ITT # 100016726

AMENDMENT NO. 003

This amendment is raised to revise the Annex A – Statement of work (SOW) and to answer Bidders' questions.

SKID DIAGRAM - 4-WAY BLOCK DESIGN

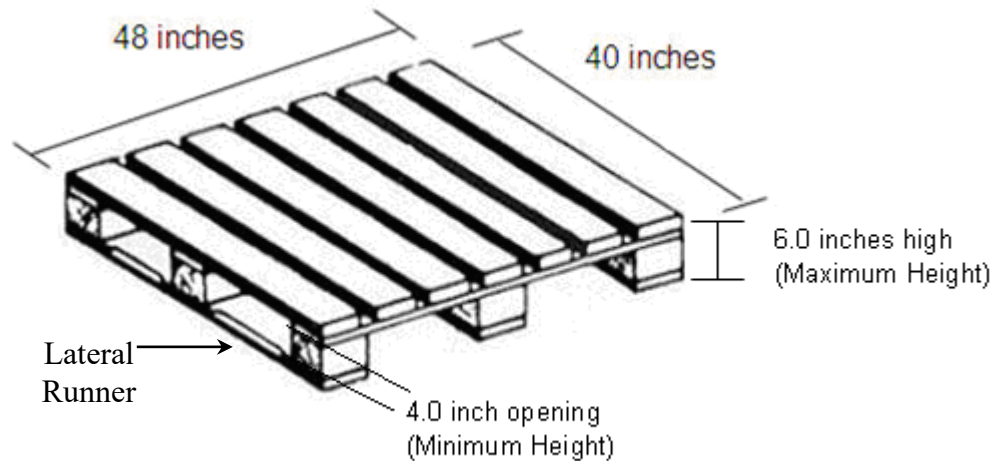
5.3.3.1 Skid Diagram and Specifications to the Canada Revenue Agency (CRA) Warehouse

The Contractor must follow the skid Diagram and specifications for the packaging of all orders shipping to:

- a. Skids used are to be four-way block style with three (3) 40" lateral runners at the bottom of the skid – one (1) at each end and one (1) in the middle.
- b. Critical skid dimensions are:
 - Length = 48.0"
 - Width = 40.0"
 - Maximum height = 6.0"
 - Minimum height gap between runners (along width) = 4.0"
- c. All lateral runners MUST have a 45° slope on all sides for power truck accessibility.

- d. Skids used are to be spruce wood construction using 3" nails with a minimum of six (6) nails per board.
- e. The skid including all contents must be a maximum weight of 2,500 lbs and a maximum height of 56".
- f. The entire skid must be shrink-wrapped a minimum of two (2) layers.
- g. To prevent damage of product and health & safety issues when offloading, stacking of skids is unacceptable.
- h. Non-returnable skids are to be used.
- i. Industry best practice for skid packaging and safety methods shall be used.
